Addendum #2

Attn: Estimator	Date: November 26, 2024
From: Lisa Donahue, Project Administrator	Pages: 25 (including cover page)
Re: Bullock Creek School District 2024 Bond Series 1	Project: 2025 Summer Projects HS/MS/Elem/Pine River/Floyd and Maintenance Building
CC:	Proj. #: A24907

ADDENDUM #2

Project: No. 24-120 2023 Bond – Series 1 2025 Improvements

DRAWING TITLE
POLE BARN MECHANICAL & PLUMBING PLAN

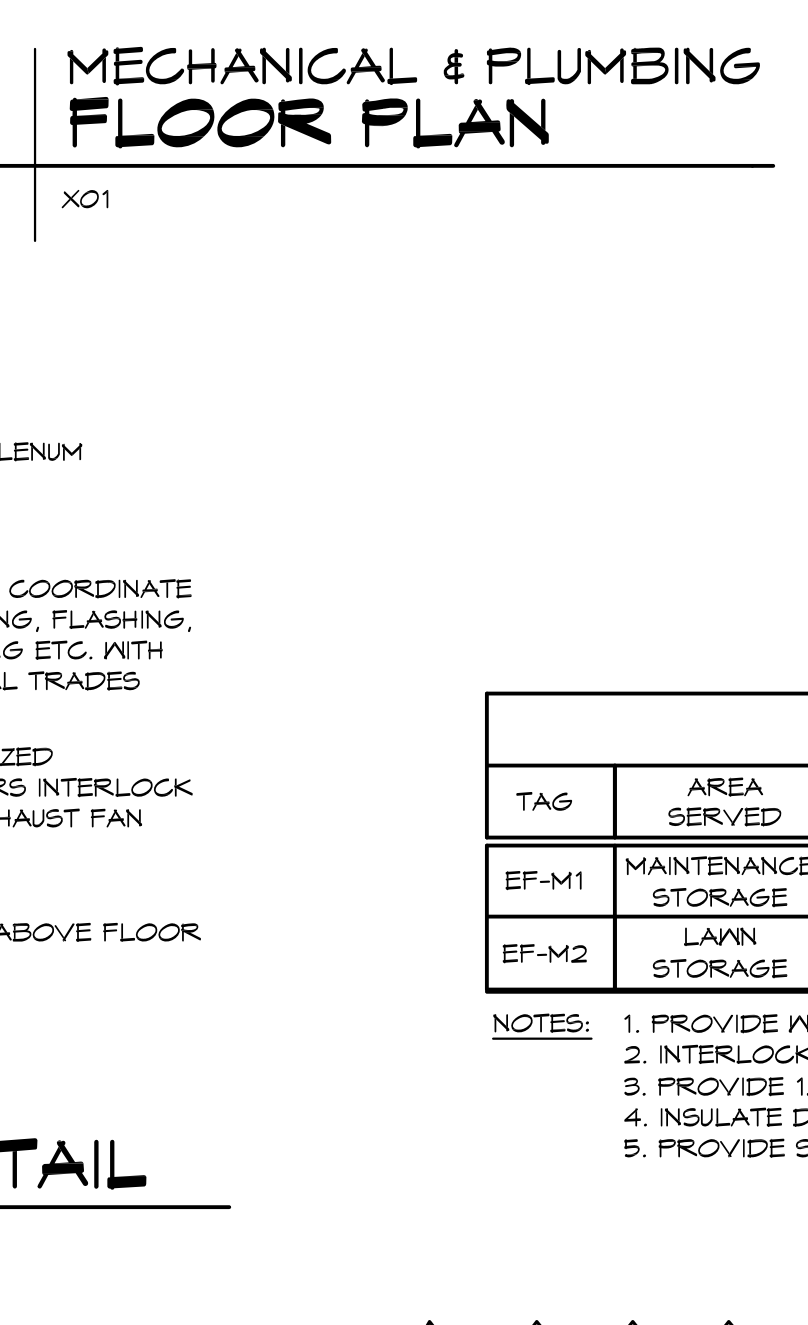
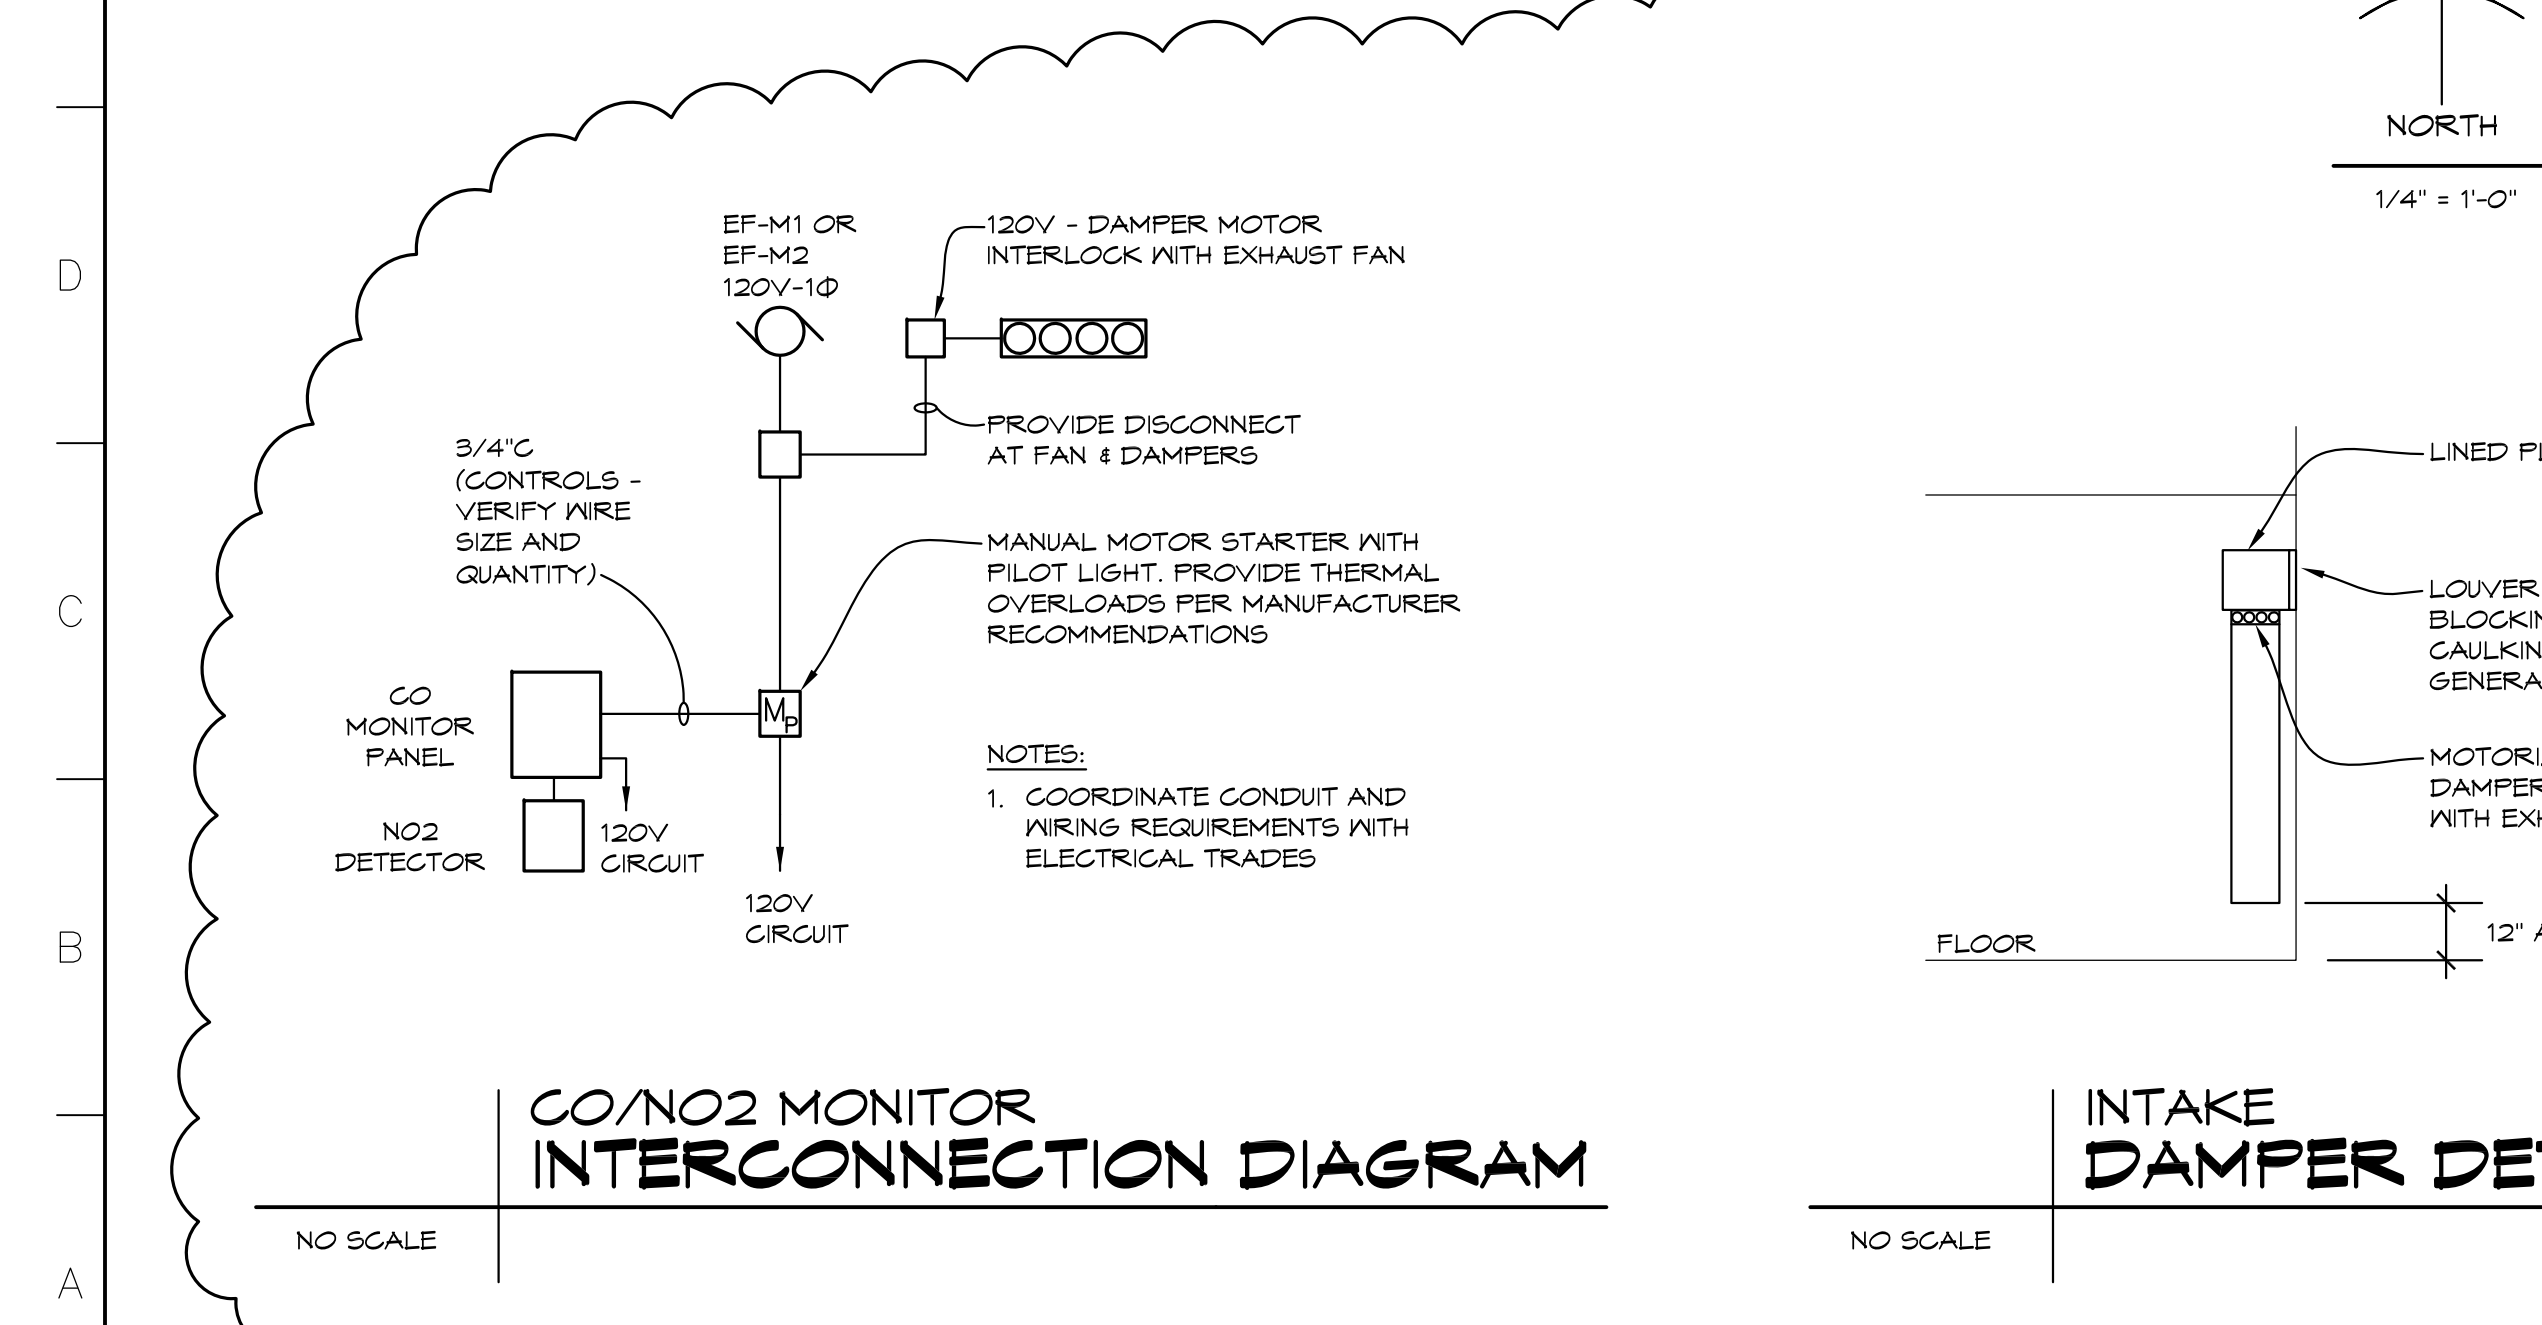
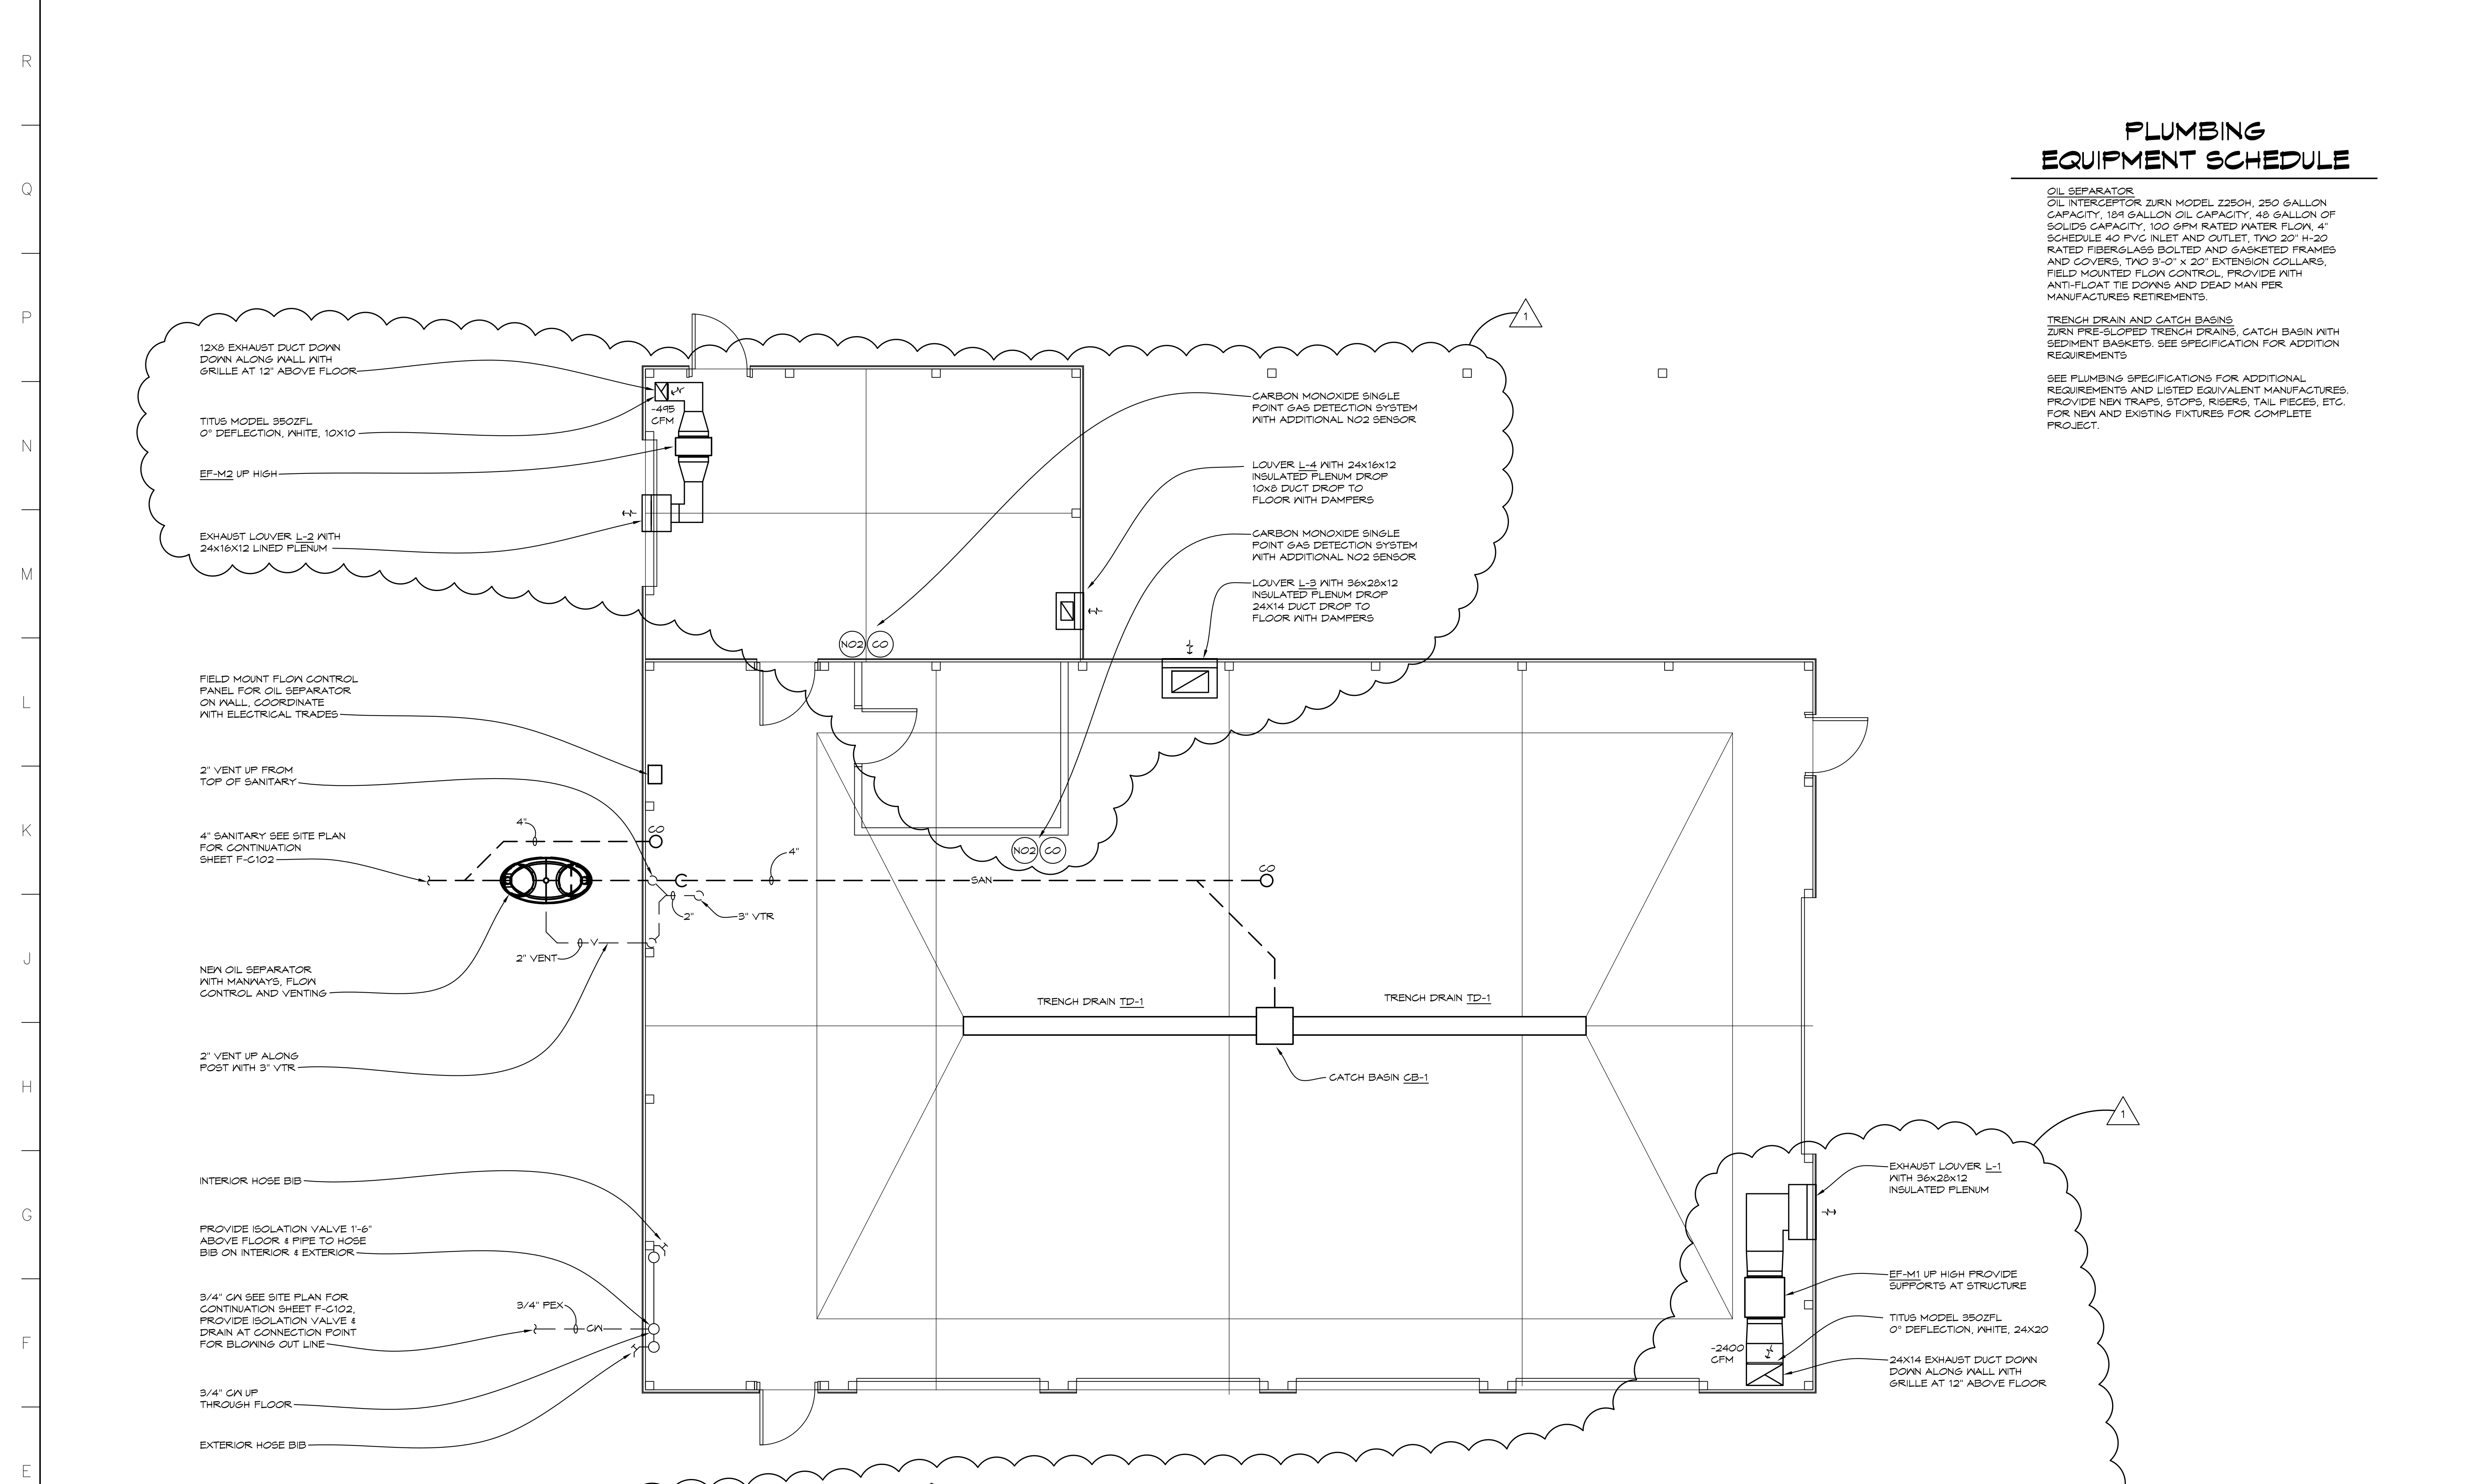
- Item #M1: Revise Sheet F-P101 as follows:
- a. Revise drawing number to be "F-MP101".
 - b. Install exhaust fans "EF-M1" and "EF-M2" with associated ductwork, grilles, louvers and dampers.
 - c. Install intakes for associated exhaust with louvers, ductwork and dampers. Dampers to be interlocked with associated exhaust fan.
 - d. Install carbon monoxide CO single point gas detection system with NO2 sensor for each exhaust fan.
